Medical University of South Carolina Amendment 3	Solicitation Number	Q191100ADD
		Date Printed	January 3, 2019
		Date Issued	January 3, 2019
		Procurement Officer	Angie DeVeaux
		Phone	843-792-2389
		E-Mail Address	deveauan@muscd.edu

DESCRIPTION: **Fabricate and Install Steel Beam-W8x18**
 USING GOVERNMENTAL UNIT: Medical University of South Carolina

Questions and Answers:

MUSC CHP 1ST FLOOR FOLDING PARTITION
DOOR (ROOM 105)

SCALE: $1'' = 1' - 0''$

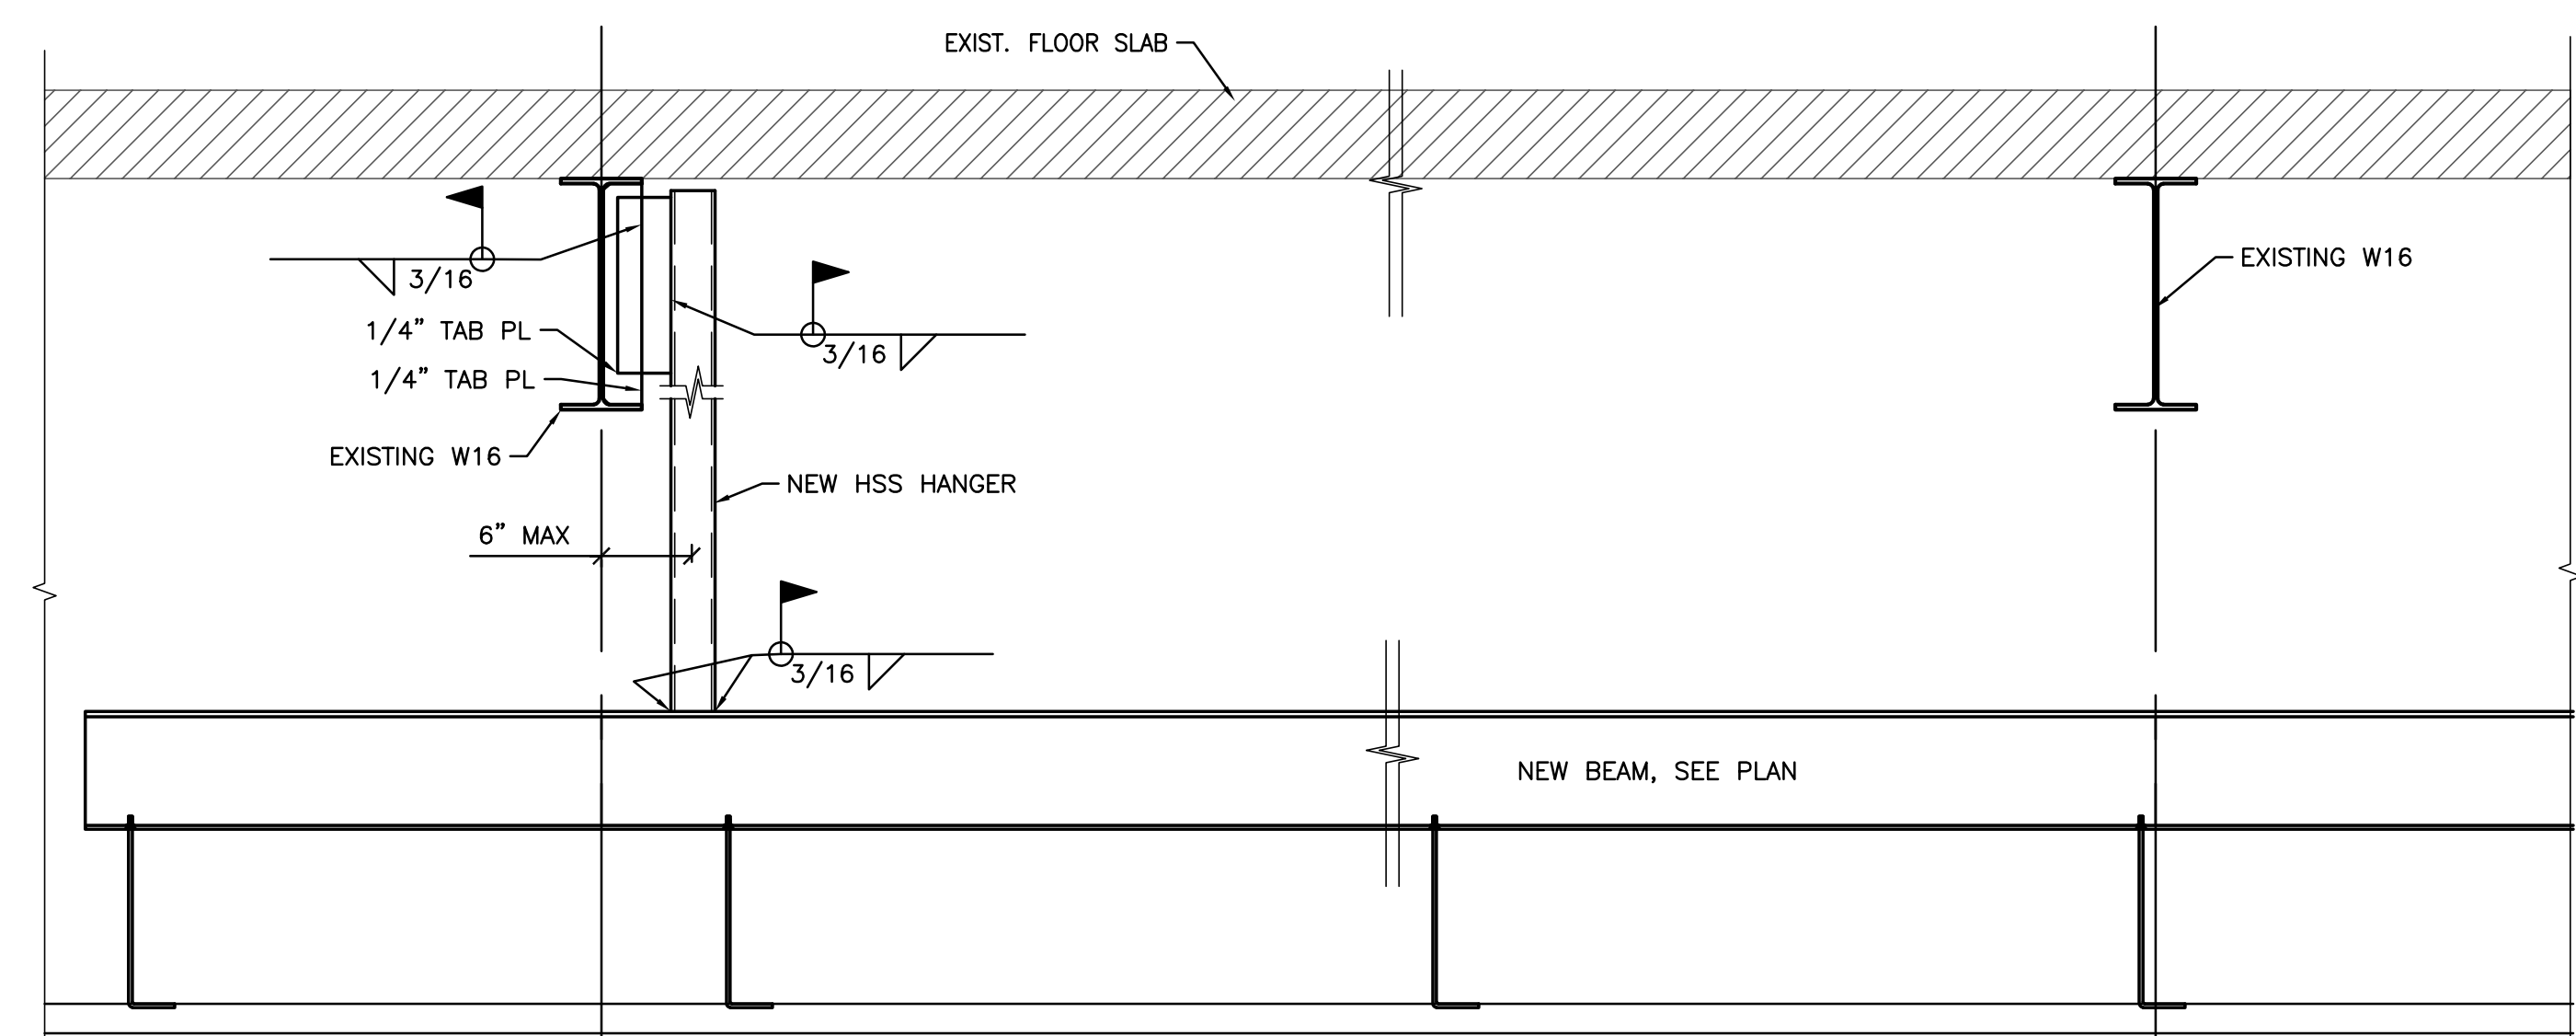
3. If the beam doesn't fist directly underneath the existing beam is there an alternate detail for he hanger?

See attached updated drawing revised 01/17/2019

- **S201 sheet 3 and S202 sheet 4 revised 01/17/2019 alternatives on hangers**
- **S201 sheet 3 revised 01/17/2019 for splice instructions**

3 ALTERNATE POST TO EXISTING STRUCTURE ATTACHMENT DETAIL
